3504 Montgomery NE - Grading and Drainage Exhibit for paving

SWOP PAVING PLAN DRAINAGE CALCULATIONS

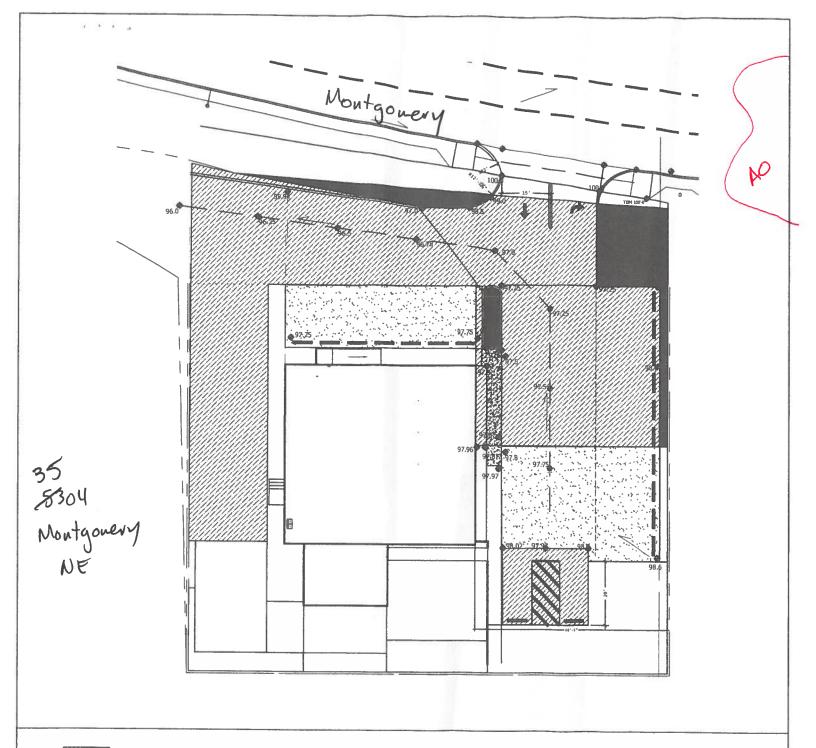
After reviewing your proposed project (over the counter) at the above-referenced location, we understand that the project will not significantly change the general grading of the site. The net increase in paved surface is less than 2000 SF, and you are not in a flood hazard zone (Zone X for this site).

As such, the project is approved for paving.

If during construction it is determined that the general grading pattern needs to be changed, or more than 2000 SF of net increase in paving will be completed, please coordinate with Hydrology Planning to ensure that the changes will not require an additional submittal.
